Re: West Ridge Mine C/007/041  
Request to Reduce Bond

<input checked="" type="checkbox"/> Permit Change	<input type="checkbox"/> New Permit	<input type="checkbox"/> Renewal	<input type="checkbox"/> Transfer	<input type="checkbox"/> Exploration	<input type="checkbox"/> Bond Release	Permit Number: ACT/007/41
Title of Proposal: WR 18-003 Culvert Replacement						Mine: West Ridge
						Permittee: West Ridge Resources, Inc

**WEST RIDGE MINE**  
 Map 7-2  
 Mine Site Drainage Map

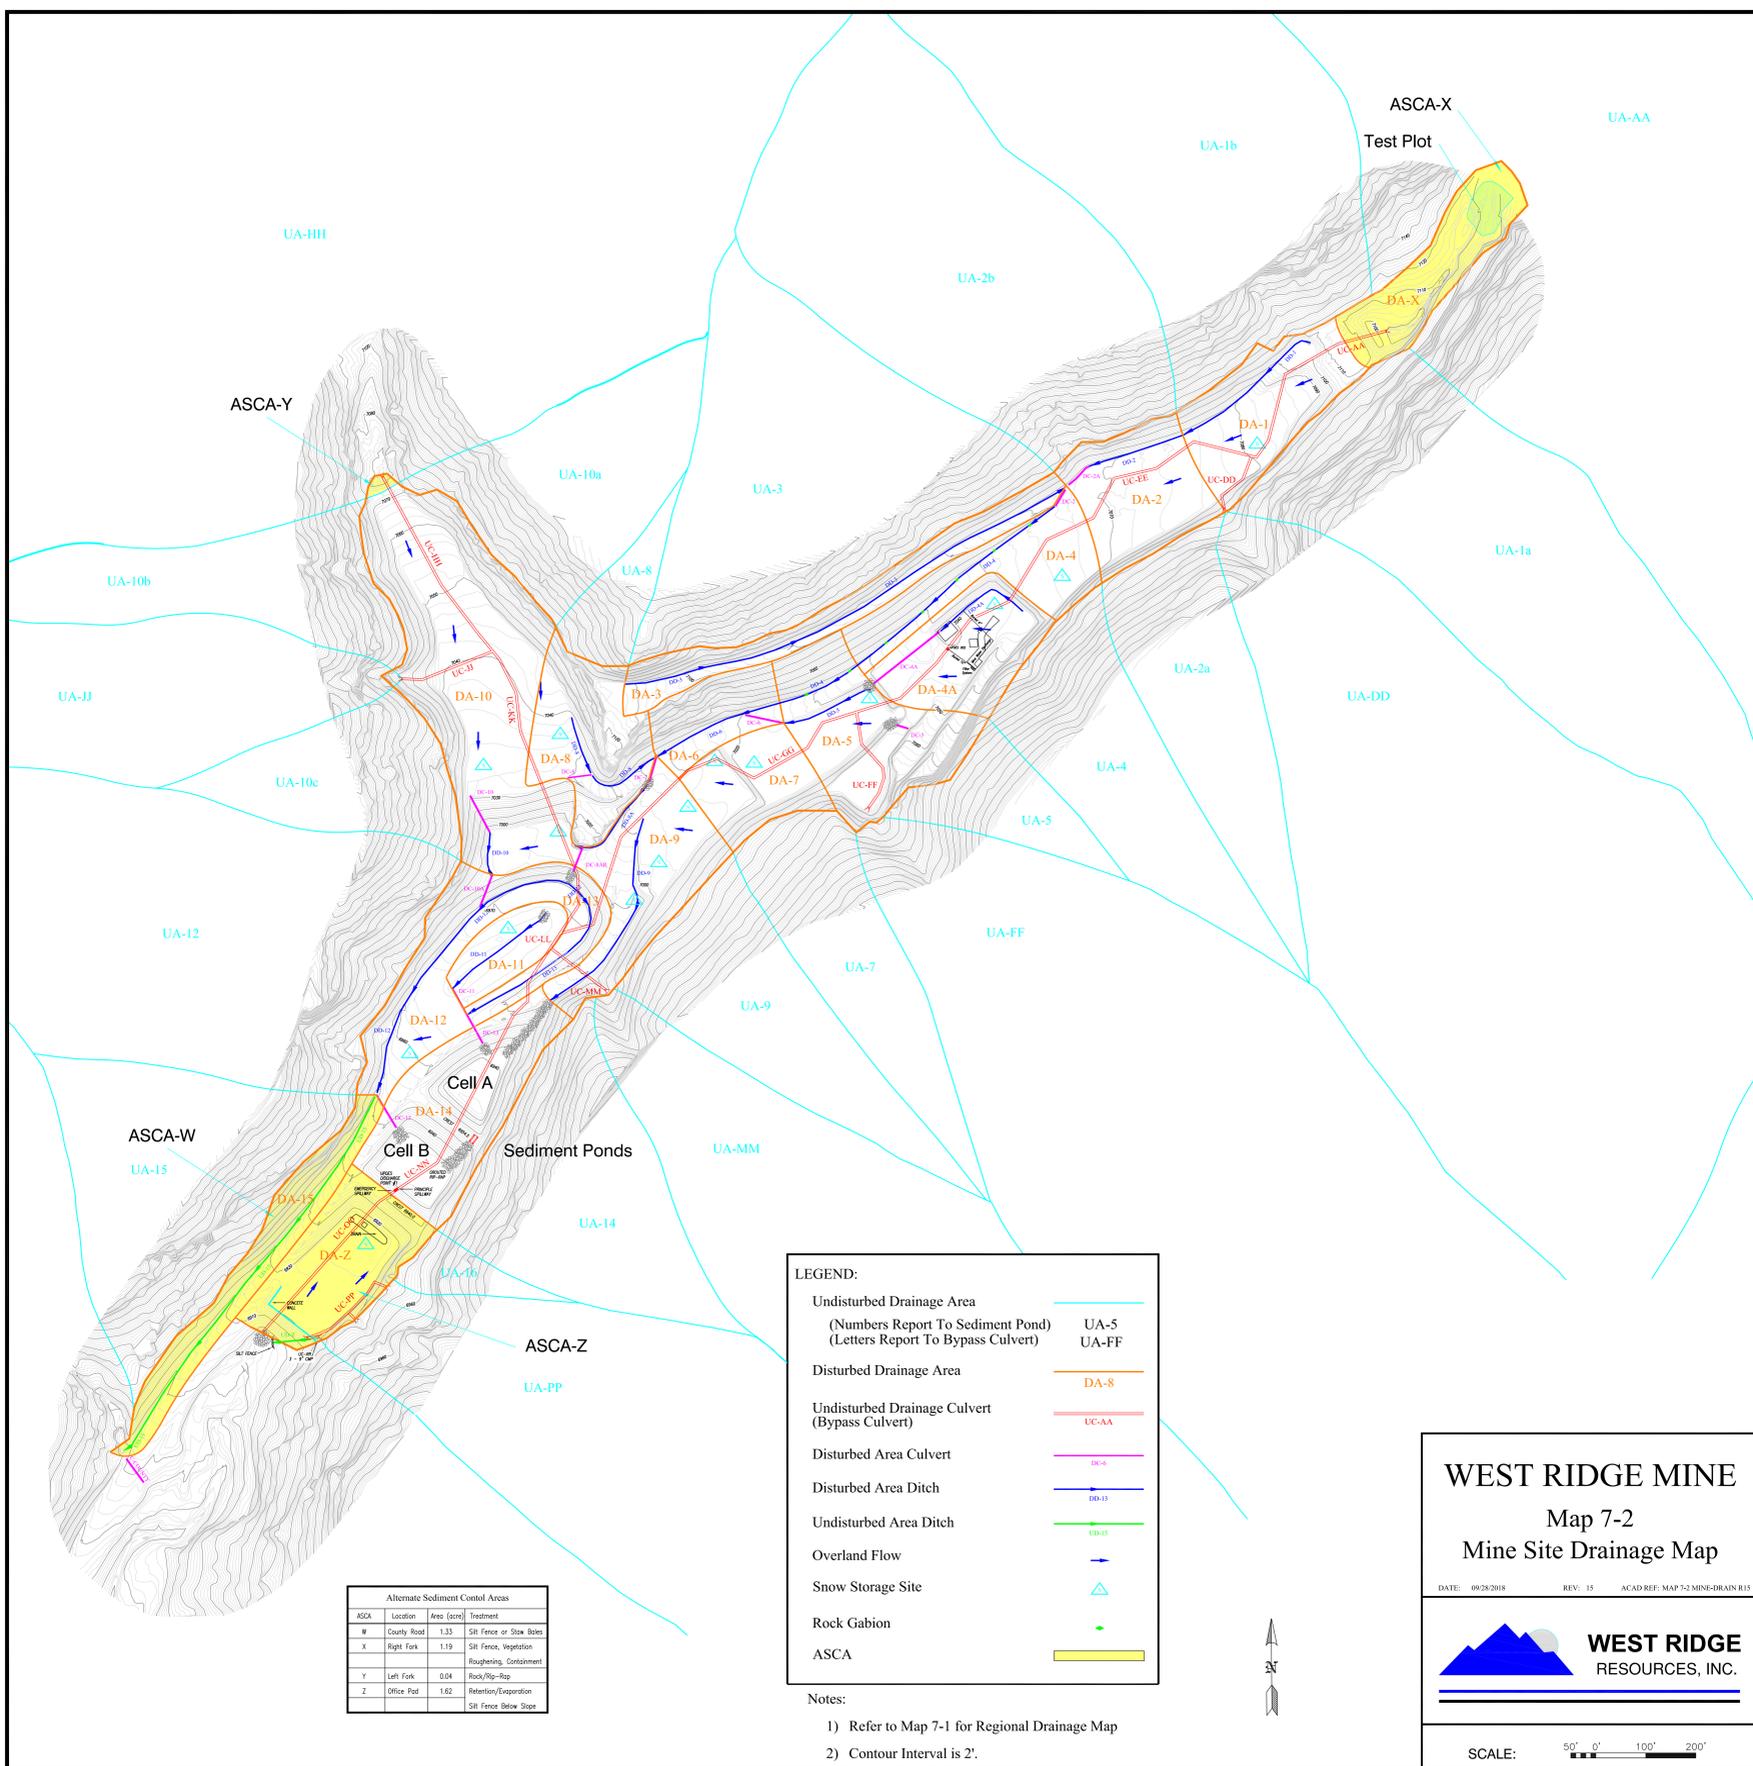
Please find the attached request to amend the West Ridge Mine C/007/041 MRP to adjust one culvert on the property. The reasoning for this amendment is to replace the 3 six inch culverts that ran underneath the road to the crusher building access road into the loadout area (DC-8AR). These 3 culverts are a continuous maintenance issue due to the fact that they are too small and over time, the road has settled and they were no longer at the appropriate grade and sediment overwhelms one or all of the inlets. We will be replacing the 3 small culverts with one 18" culvert. The repair will handle the same amount of water that is calculated to move through the watershed, but the grade and size will be fixed to minimize or eliminate future plugging.

During this amendment, I noticed that culvert DC-8A was replaced by culvert DC-8AR in approximately 2008, however the MRP was never changed to reflect this, and it has gone unnoticed. This amendment describes these changes and associated calculations. Please note that the Culvert Design Summary tables located in Appendix 7-4 show that DC-8AR was originally put in to be a relief culvert for DC-8A, and the calculations showing that DC-8AR is capable of receiving more water than DC-8A, so the table, information, and maps are now accurate. The calculations also include any additional potential mine discharge water. Please refer to the text on page 1a for a full description. Sorry about the confusion with this amendment.

- f) **In 2003, DC-8AR was designed and installed to serve as a relief culvert to DC-8A due to its continual maintenance issues. In 2008 it was determined that DC-8A was poorly designed and was ultimately installed in a location which was hindering mining operations, and so it was removed. DC-8AR is now used in place of DC-8A.**

**DC-8AR was added to replace DC-8A. (See page 1a and Table 15)**

**DC-8A replaced by DC-8AR**
